DEPARTMENT OF CITY PLANNING RECOMMENDATION REPORT

North Valley Area Planning Commission

APCNV-2017-1102-ZC Date: July 6, 2023 Case No.:

PROJECT 8553 N. Noble Avenue

Colored Elevations

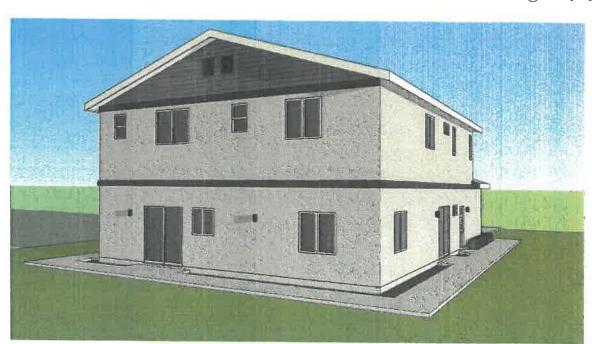
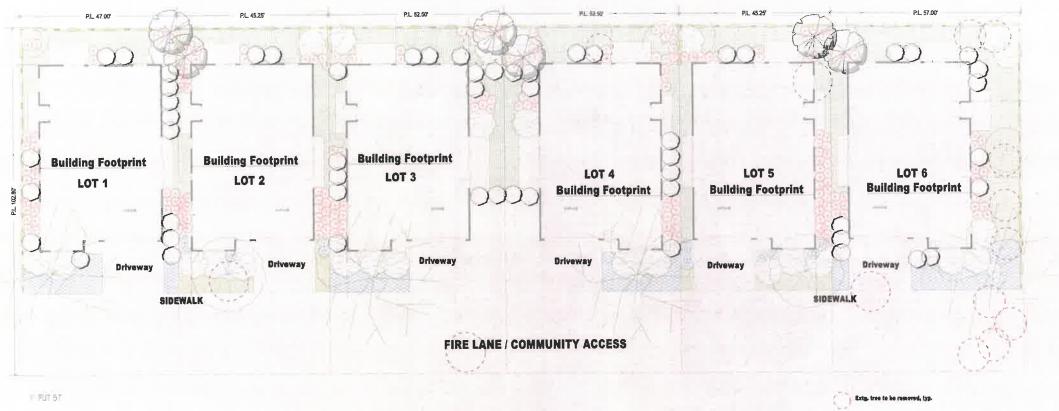
•	Elevations and renderings are inconsistent; floor plans and elevations are inconsistent.	We think the site plans and elevations are consistent. We have a Model "A" and "B." Model "A" is the mirror of Model "B," and we checked the plan and they are correct. We believe the elevations and renderings match.

•	What is the line on the renderings? Is it different planes?	Roof plan provided
•	The application of the one additional material, the siding up in the gable ends, could probably be better-used closer to ground level.	No response.
Climat	te-Adapted Design
